RENESAS TECHNICAL UPDATE

Product Category	MPU/MCU		Document No.	TN-SH7-A819A/E	Rev.	1.00
Title	The error correction and addition about LCD controller (LCDC)		Information Category	Technical Notification		
Applicable Product	SH7203 Group SH7263 Group	Lot No.	Reference Document	<ul style="list-style-type: none"> • SH7203 Group Hardware Manual (REJ09B0313-0300) • SH7263 Group Hardware Manual (REJ09B0290-0300) 		
		ALL

Figure 24.4 Flowchart for Power-Supply Control Sequences

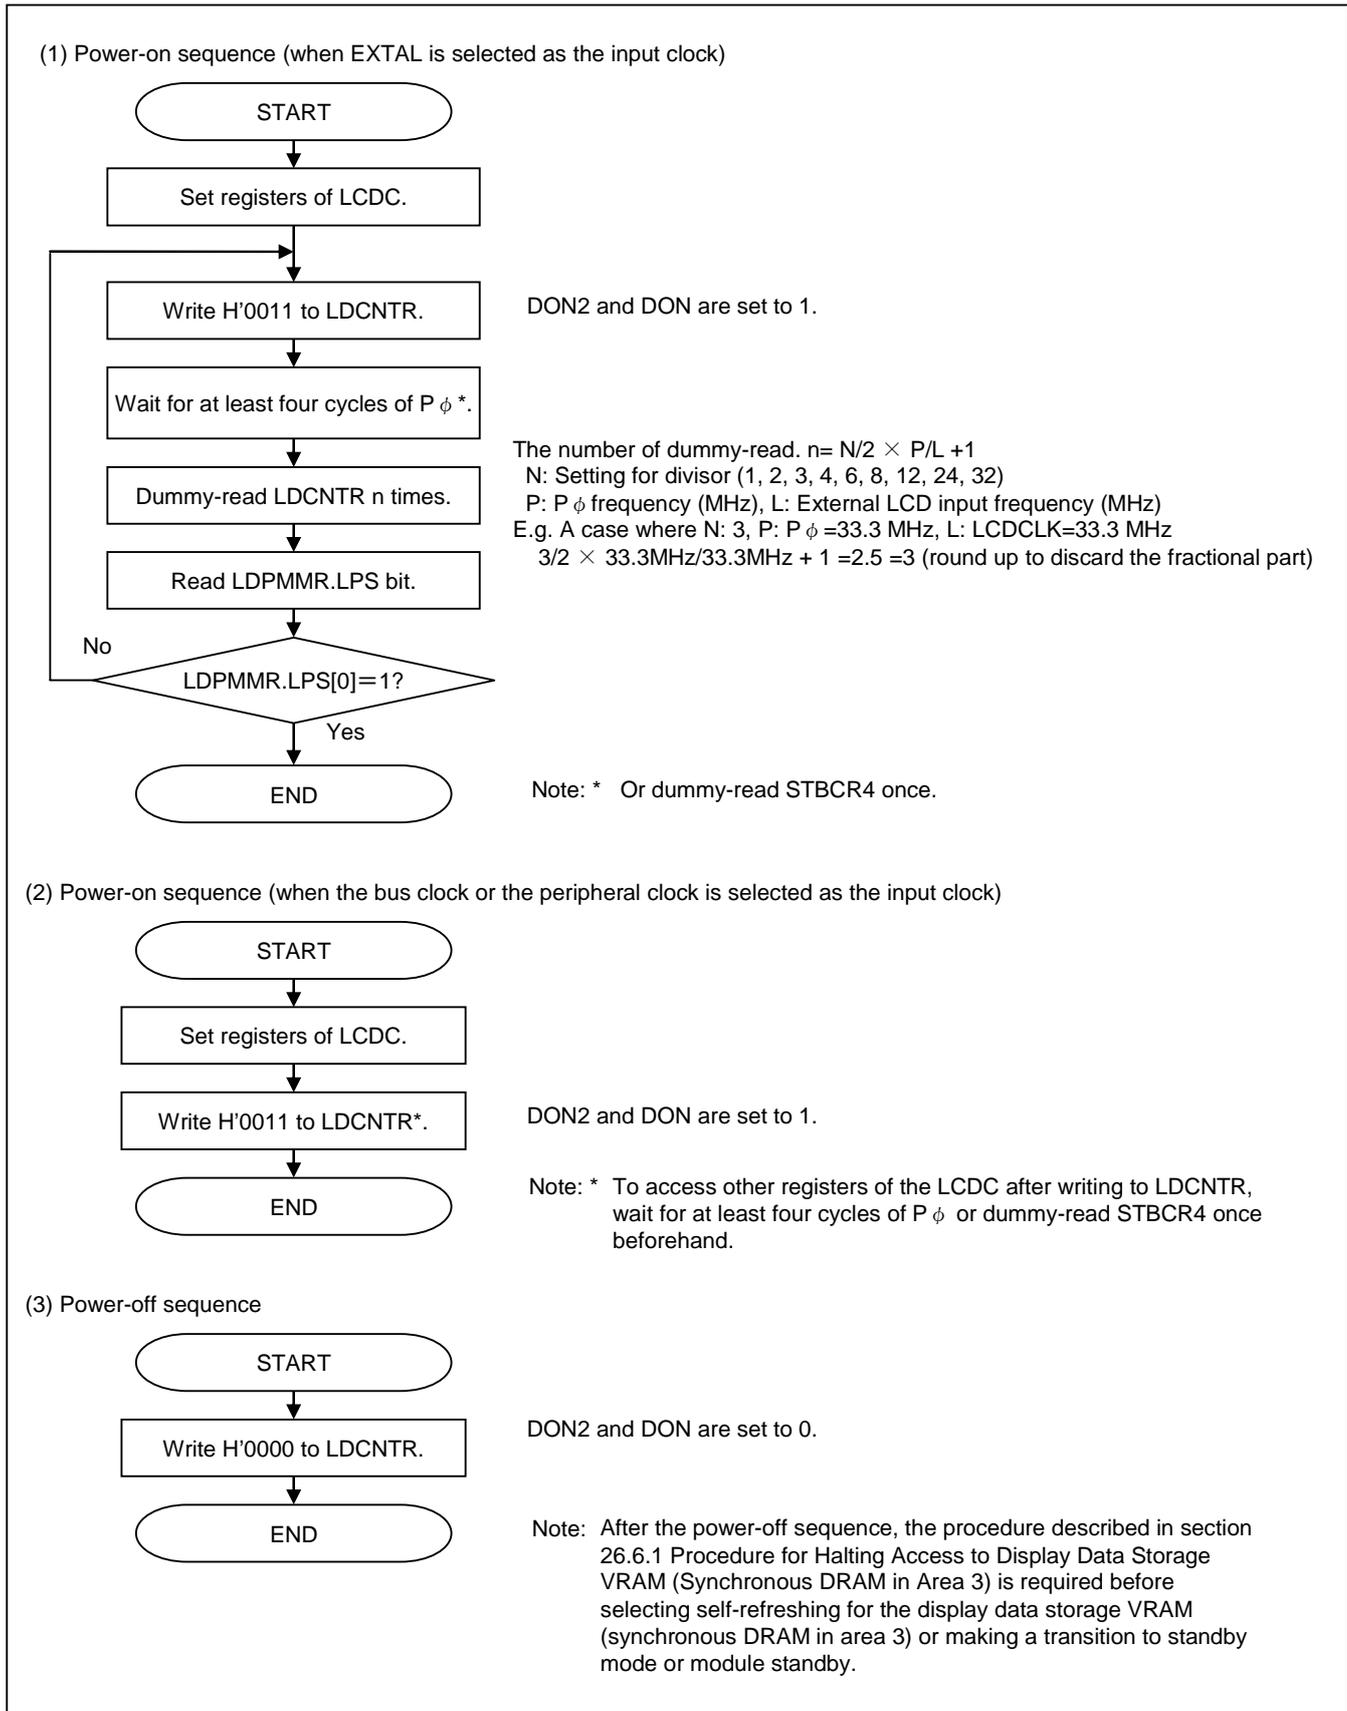
Figure 24.4 gives the flowcharts for power-supply control sequences, figures 24.5 to 24.8 are summary timing charts for the power-supply control sequences, and table 24.6 is a summary of the available power-supply control-sequence periods.

3. Added Figure 24.4
